EAGLE TECHNICAL BULLETIN

Eagle Technical Bulletin Number: **TB-E407-789-6**

Purpose: To add an upgraded Engine Gearbox Vent Line Assembly

| DE APPR. | DS  | GEARBOX VENT LINE UPGRADE | NTS |

FIGURE 1: GEARBOX VENT LINE UPGRADE KIT INSTALLATION

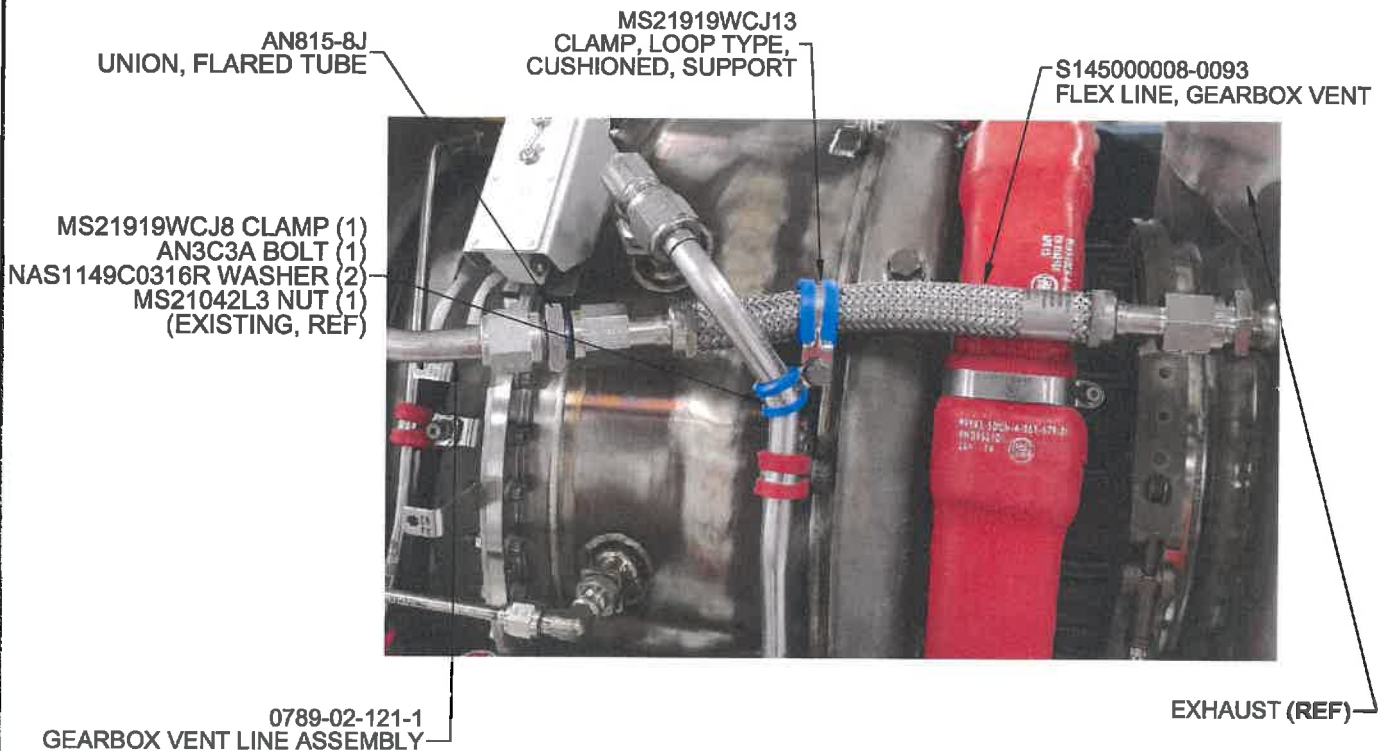
Eagle Copters has developed this Technical Bulletin to provide an upgraded Gearbox Vent Line Assembly that includes a flexible portion to prevent stresses due to misalignment. Compliance with this Technical Bulletin requires the parts listed in Table 1 below:

1. Remove 0789-02-119-1 Engine Gearbox Vent Line Assembly per ICA-E407-789, Section 79. Retain clamping hardware and clamps.
2. Install 0789-02-121-1 Engine Gearbox Vent Line Assembly onto engine gearbox and route toward engine exhaust. See Figure 1.
3. Install AN815-8J Flared Tube Union onto 0789-02-121-1 Engine Gearbox Vent Line Assembly. See Figure 1.
4. Install S145000008-0093 Flex Line onto the AN815-8J Union and onto the Engine exhaust duct fitting.
5. Torque all lines per ICA-E407-789 and clamp as shown in Figure 1 using new MS21919WCJ13 Clamp and existing (retained) clamp and hardware.
6. Notify Eagle Copters that this Technical Bulletin has been accomplished by filling in the attached form (sheet 3) and emailing it to Eagle Copters.
7. Make entry into aircraft technical reports to indicate TB-E407-789-6 has been completed.
